## RANCHO MURIETA COMMUNITY SERVICES DISTRICT

### IMPROVEMENTS COMMITTEE

# MEMORANDUM

Date: December 28, 2016  
To: Improvements Committee  
From: Paul Siebensohn, Director of Field Operations  
Subject: Correspondence from Michael Davis, Robert Hannaford and David Lewis

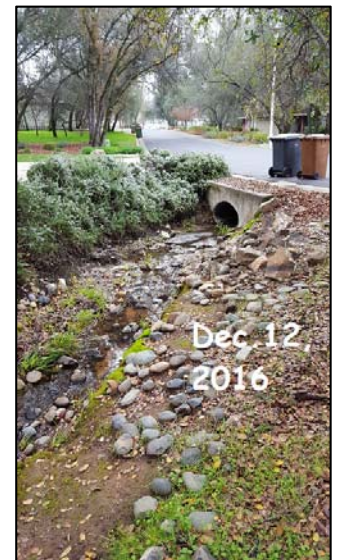
The area across the roadway at 4 Park Via Del Cerrito flooded twice since the pipe was installed.

First time: This was a result of a wood pile stacked up between lot 1126 and the drainage ditch that had washed some of the wood into the pipe during a heavy rain event and caused it to plug up in January 2009.

After the first event I have staff check this culvert, and sometimes myself as shown in photo to the right, before each large predicted storm. I had also had staff remove some concrete and rocks that were limiting the flow into the upstream side of the pipe.

**FIGURE NO. 1**

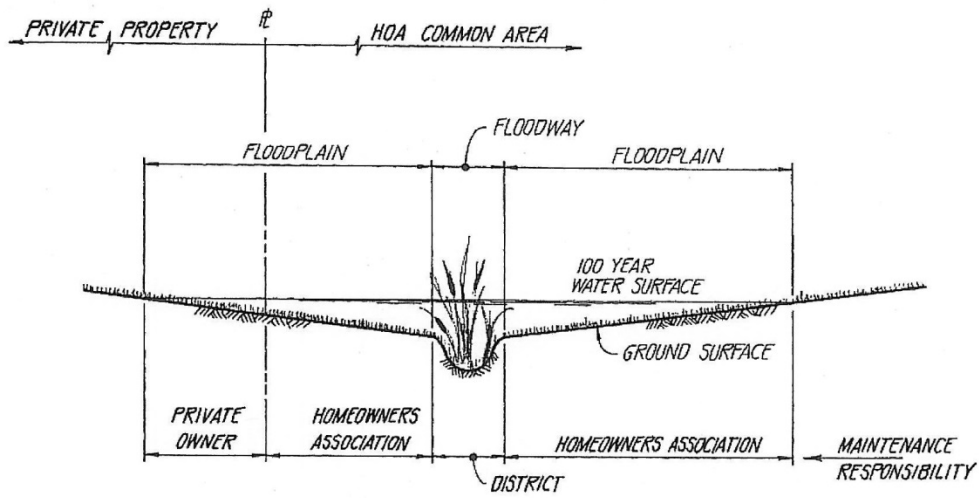
For general reference, the figure below shows the delineation of responsibilities between District and others within the District.
